Access Compliance Report

Public Rights-of-Way

Intersection ID: N/A	Main Street: WALNUT_LOOP_RD	Cross Street: WOODBINE_WALK_RD	Location: NE
ADA ID: FBD1F7E5E179	Ramp Type: Perp	Initial Pass/Fail: Fail	Overall Compliance: No
		Severity Score: 37.5

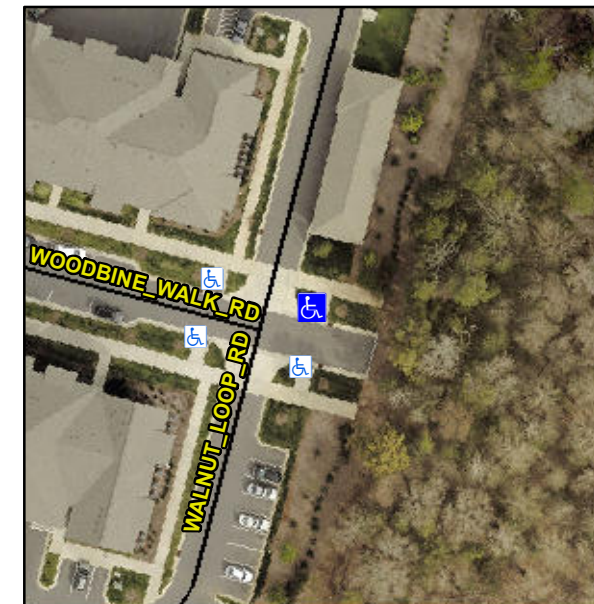
R304.2.2, R304.5.3

Compliance	Description	Data	Compliance	Description	Data
N/A	Ramp Length (in)	80.0	No	Ramp Slope (%)	9.0
Yes	Ramp Width (in)	94.0	No	Ramp XSlope (%)	7.6
N/A	Flare Type LT	N/A	N/A	Flare Type RT	N/A
N/A	Flare Slope LT (%)	N/A	N/A	Flare Slope RT (%)	N/A
N/A	Flare Traversable LT?	N/A	N/A	Flare Traversable RT?	N/A
N/A	Landing Length (in)	N/A	N/A	DWS Provided?	N/A
N/A	Landing Width (in)	N/A	N/A	DWS Contrast?	N/A
N/A	Landing Slope (%)	N/A	N/A	DWS Length (in)	N/A
N/A	Landing X Slope (%)	N/A	N/A	DWS Full Width?	N/A
N/A	Landing Curb? (Y/N)	N/A	N/A	DWS Offset (in)	N/A
N/A	Shared Landing?	N/A			
N/A	Gutter Ponding?	N/A	N/A	Gutter Slope (%)	N/A
N/A	Gutter Lip Ht (in)	N/A	N/A	Gutter X Slope (%)	N/A
N/A	Painted X Walk1?	No	N/A	Painted X Walk2?	N/A
	X Walk 1 Direction	To SW		X Walk 2 Direction	N/A
N/A	X Walk 1 Width (in)	N/A	N/A	X Walk 2 Width (in)	N/A
	X Walk 1 Slope (%)	1.6		X Walk 2 Slope (%)	N/A
	X Walk 1 X Slope (%)	3.3		X Walk 2 X Slope (%)	N/A

Remove & Replace Entire Ramp.
